No: 25-063

DAUPHIN COUNTY SUBDIVISION/LAND DEVELOPMENT REVIEW REPORT

Plat Title: Final Minor Subdivision Plan for Harrisburg Postal Employees Gun Club

Project Description: Create one new 12+ acre lot

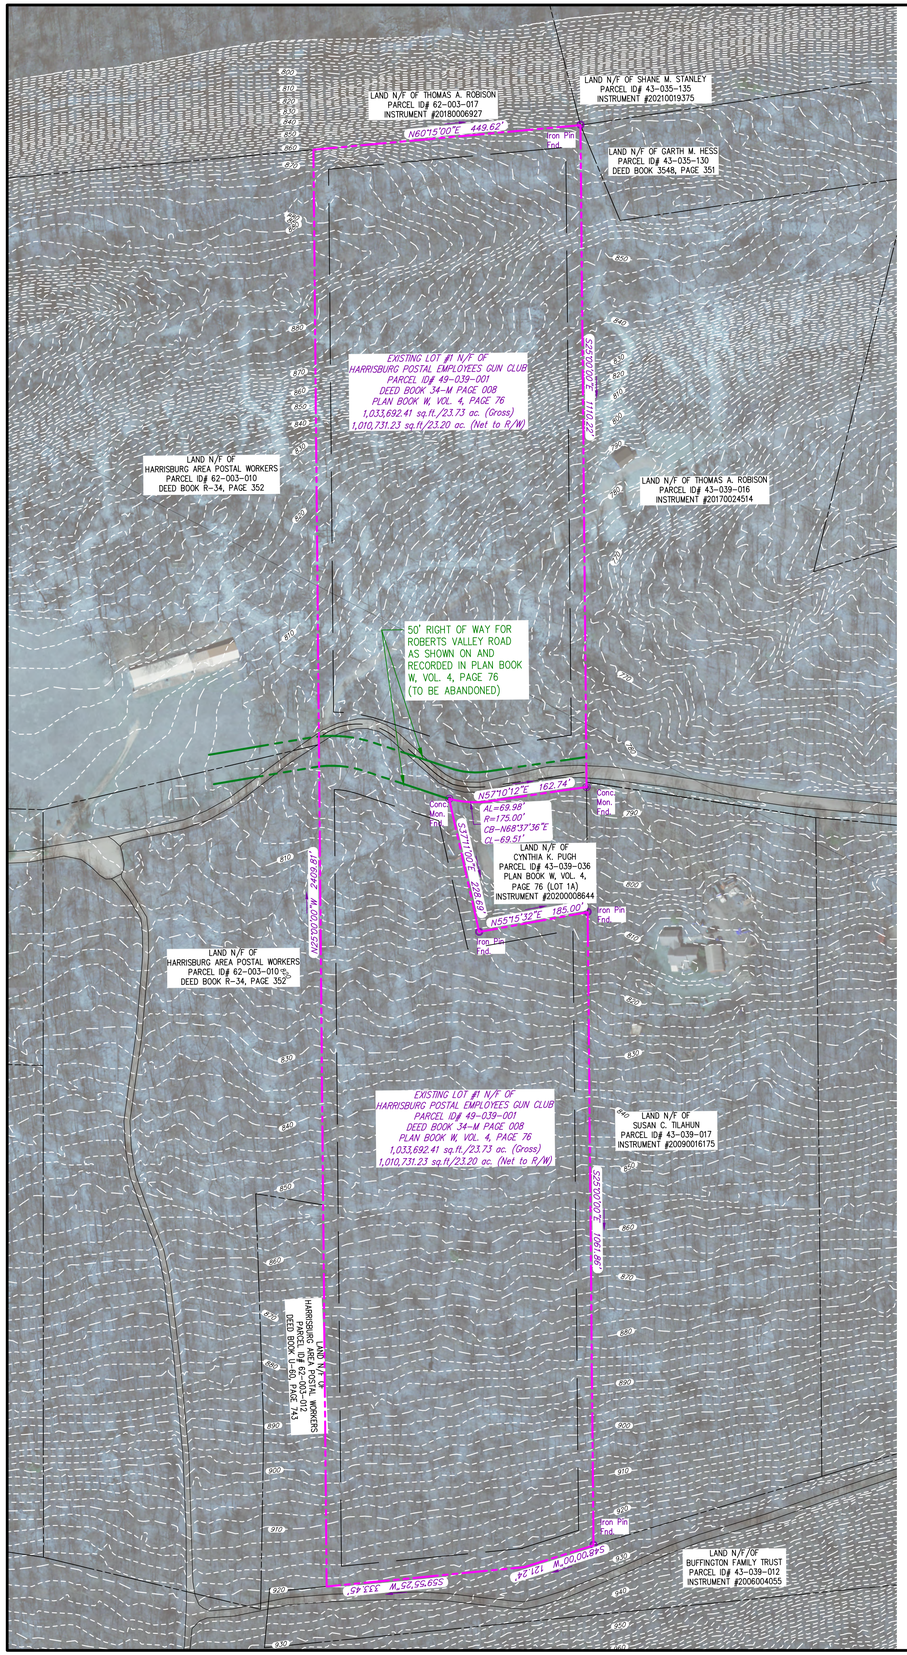
1. According to GIS aerial imagery residual Lot 1 contains a significant amount of area in excess of 12% slope. The average slope of the lot shall be determined to determine if the lot is subject to the Steep Slope Provisions in Article 11, and should be reviewed by the Township Engineer for compliance.
2. Please include PA Highway Occupancy Permit statement on the plan. An example statement is: "*Access to the State/Township Street is authorized by a state/township occupancy permit. No Building construction or work within the State/Township Street R/w may commence without said permit*."
3. Access easements and maintenance agreements shall be provided between all property owners that utilize the paved access road.
